## **ADDENDUM #1**

Bid: Golf Course Well Inspections (Bid #PUR0818-039); Dated: August 23, 2018

**Subject:** Addendum #1 (1 page)

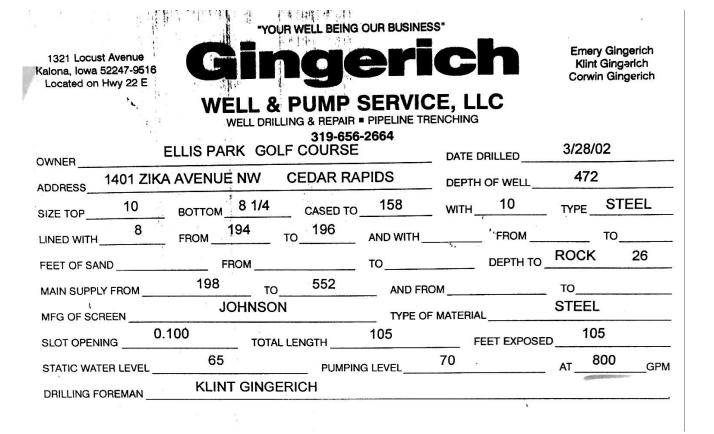
**Question:** What depth is the pump set in the well at Ellis? The well depth is 472', but the bid does not contain the pump depth and size of riser pipe?

Answer: Please see below for the well information:
